ADDENDUM TO THE CONTRACT

Gastineau Elementary School Renovation

Contract No. E11-137

ADDENDUM NO.: FOUR

SHEET TITLE:
DEMOLITION PLAN
DUCTWORK
AREA A&B

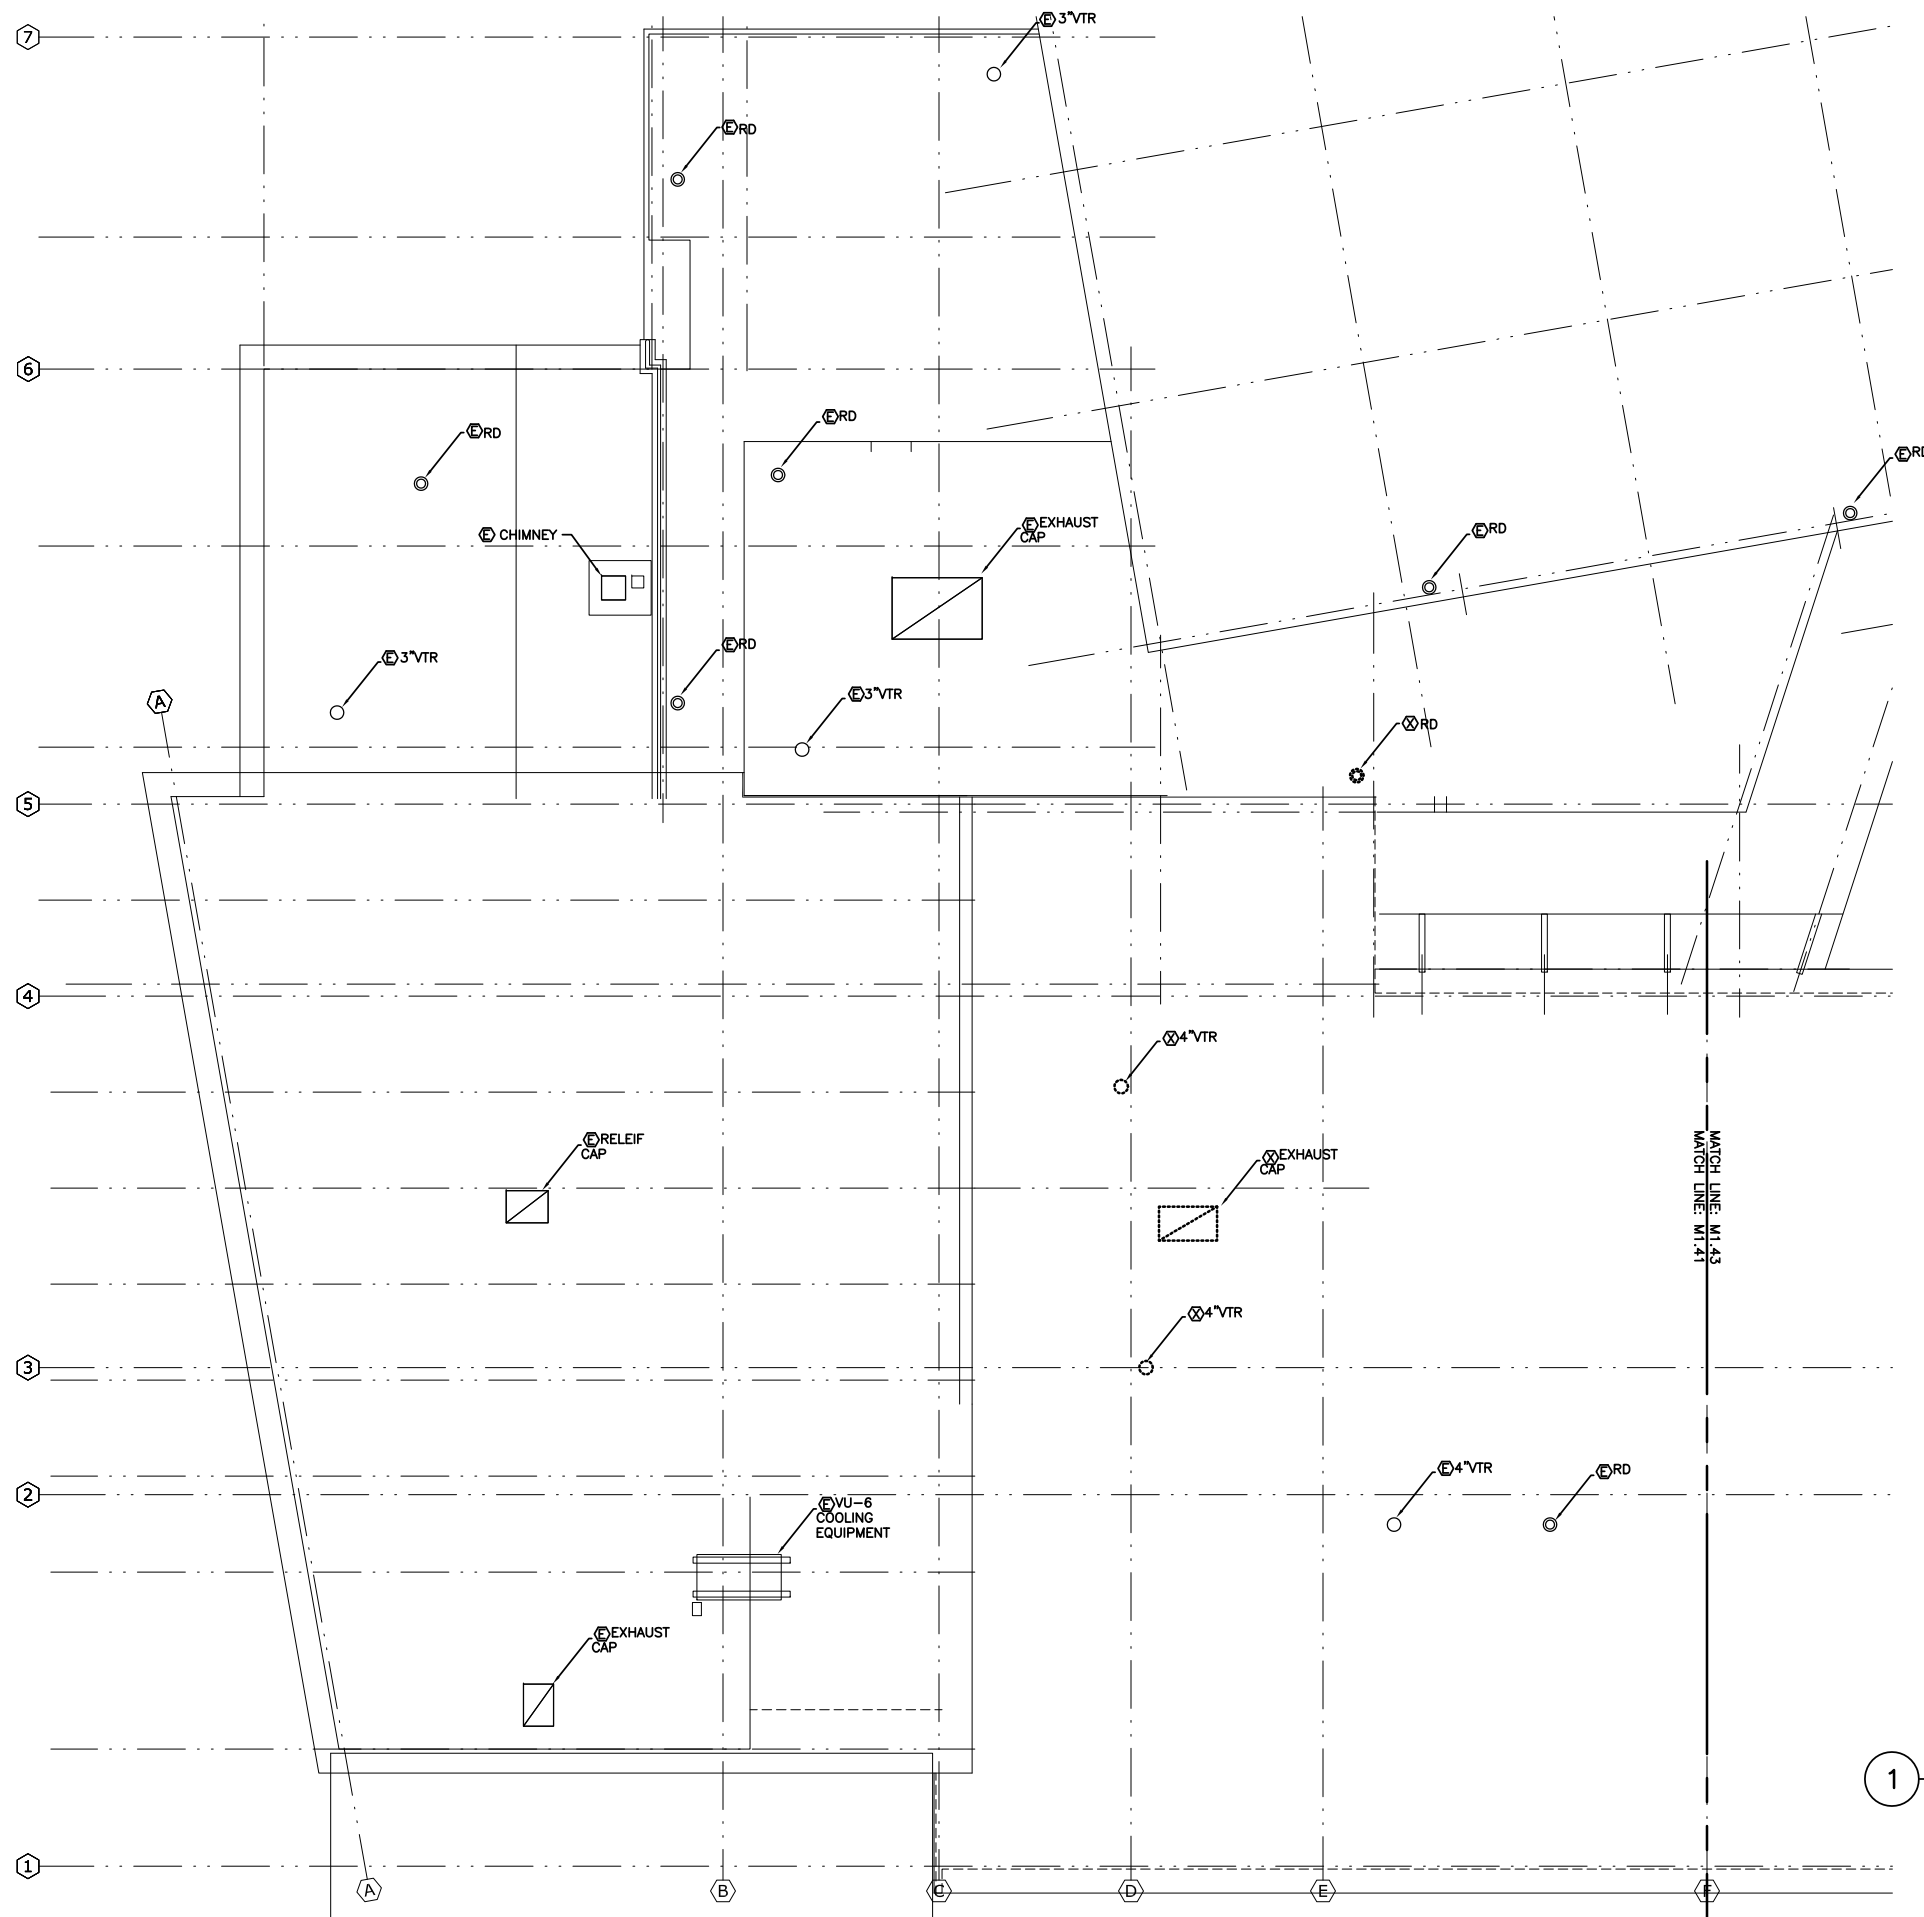
Replace sheet in its entirety with M1.31 included with addendum. This sheet replaced to correct base plan.

SHEET TITLE:
DEMOLITION PLAN
ROOF
AREA A&B

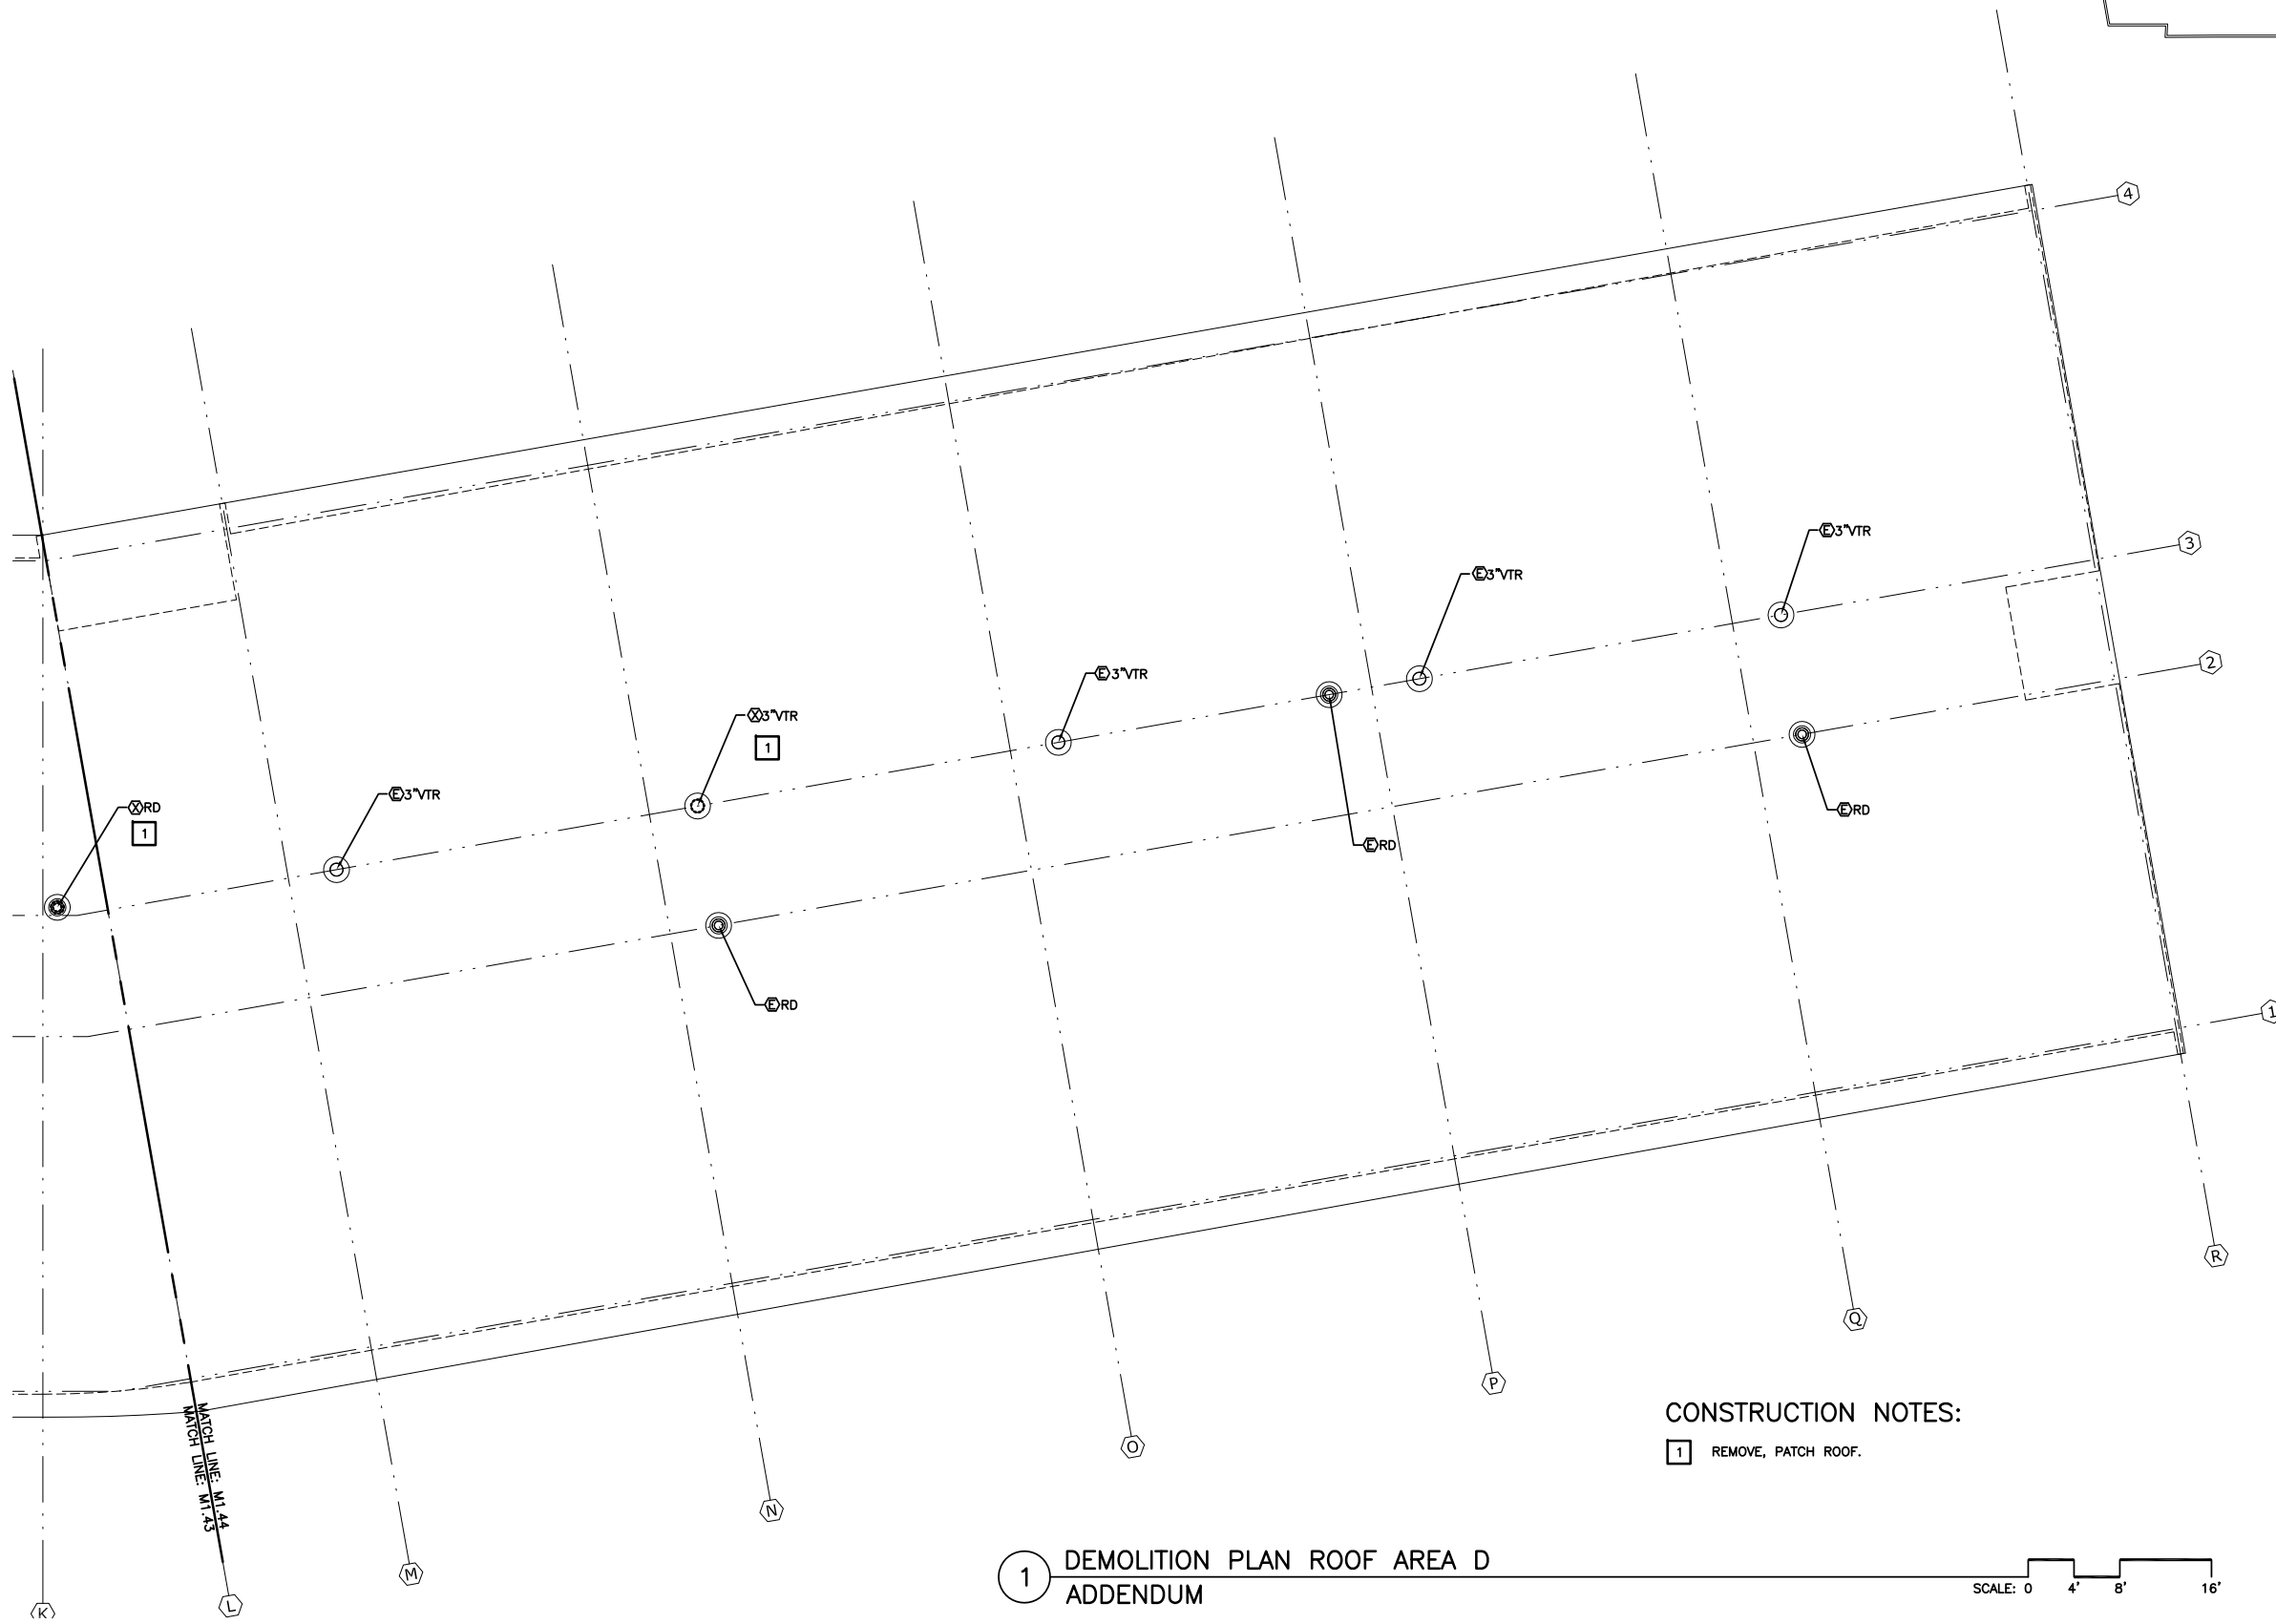
Replace sheet in its entirety with M1.41 included with addendum. This sheet replaced to correct base plan.

SHEET TITLE: DOMESTIC PIPING UNDERGROUND AREA C	
DATE:	NOV 15, 2010
REVISION:
CHECKED BY:	DM
DRAWN:	KB, LH

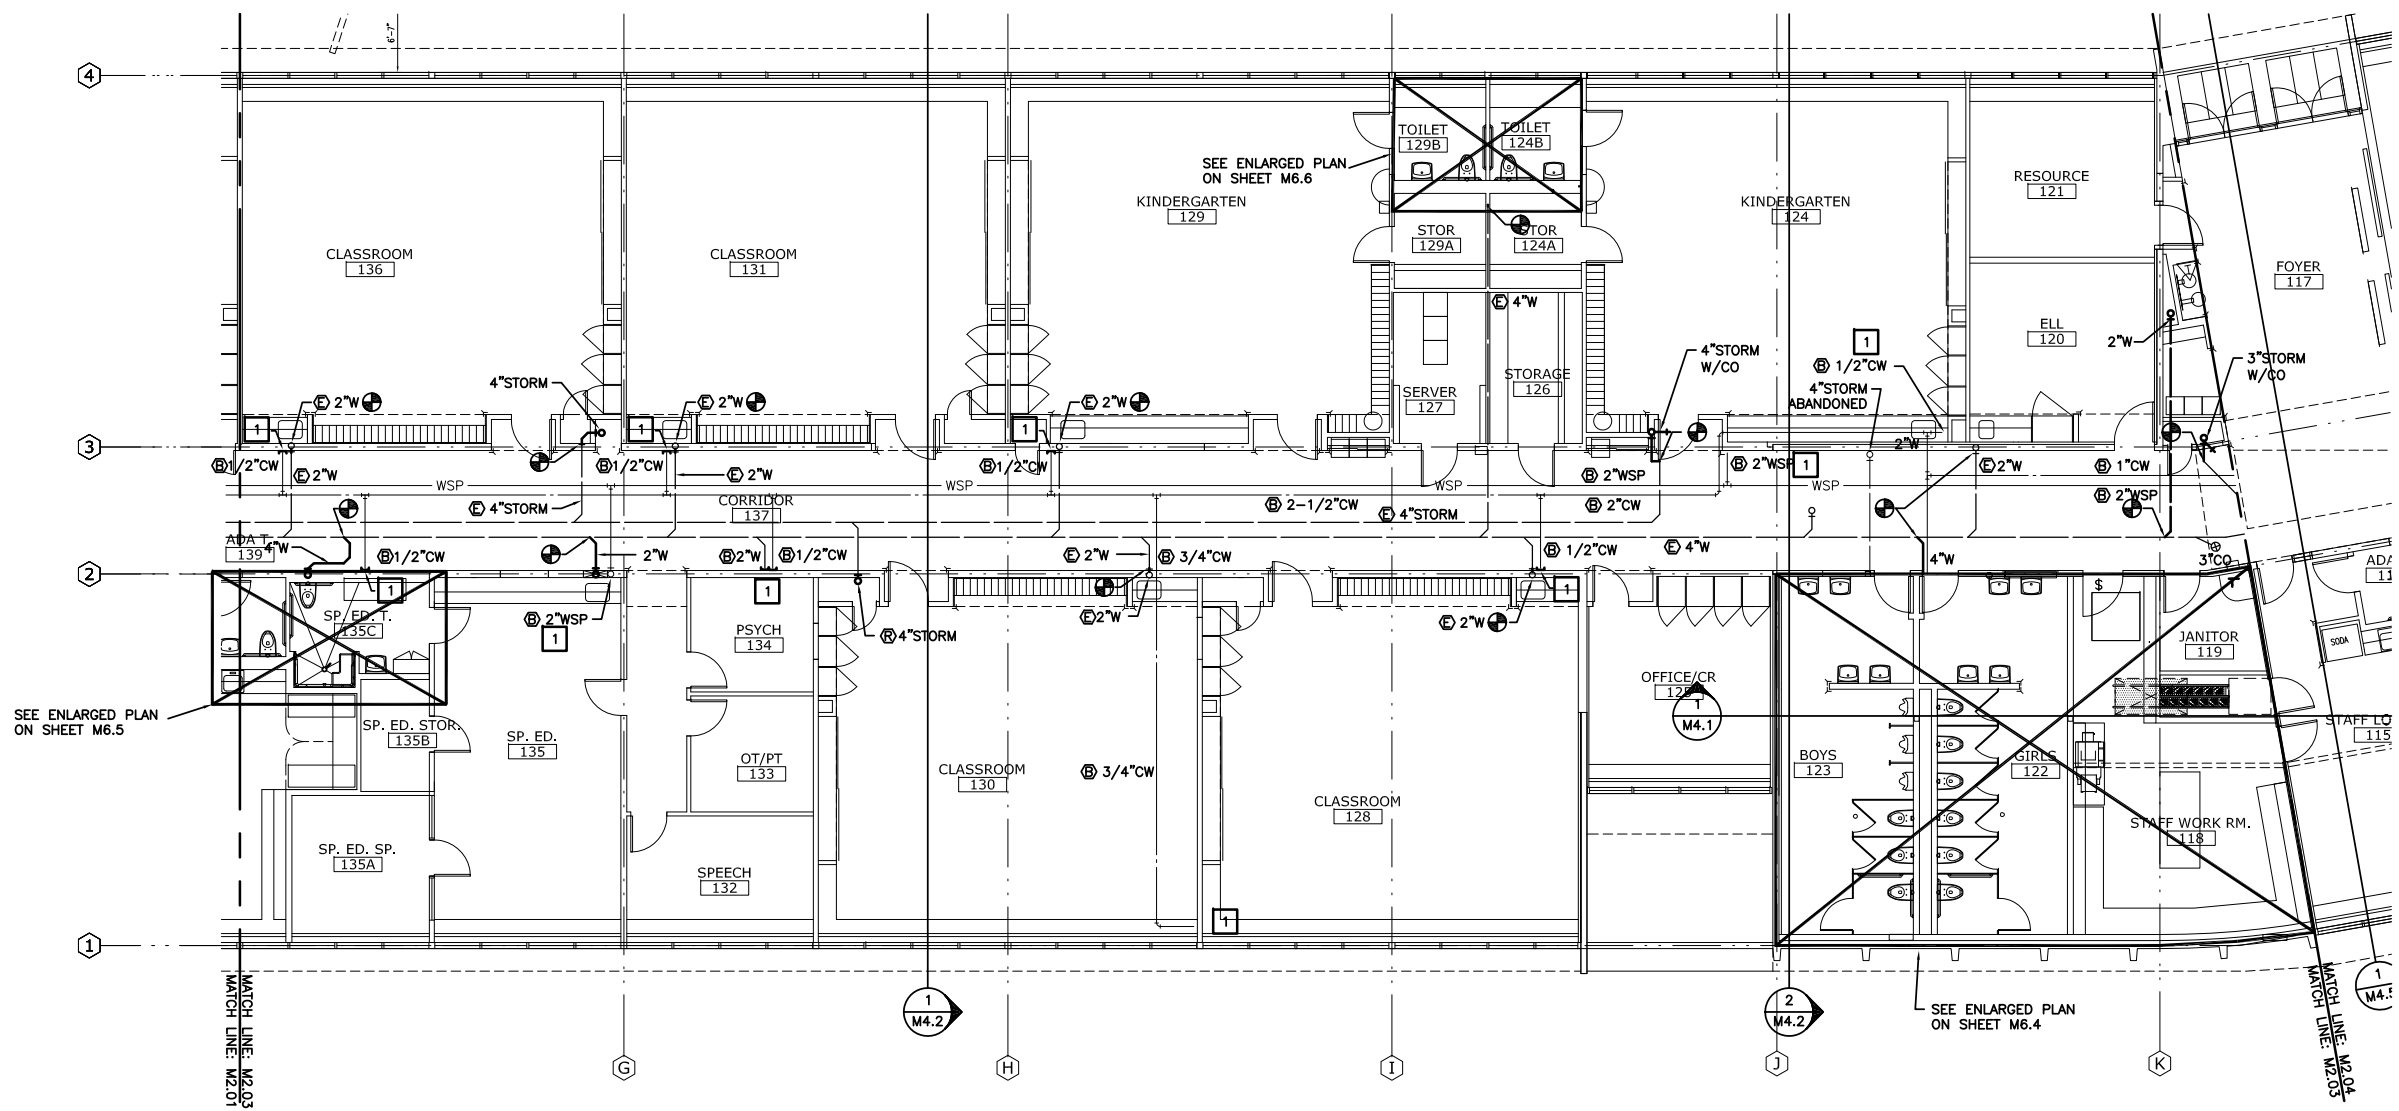
Replace sheet in its entirety with M2.03 included with addendum. This sheet replaced to correct base plan.
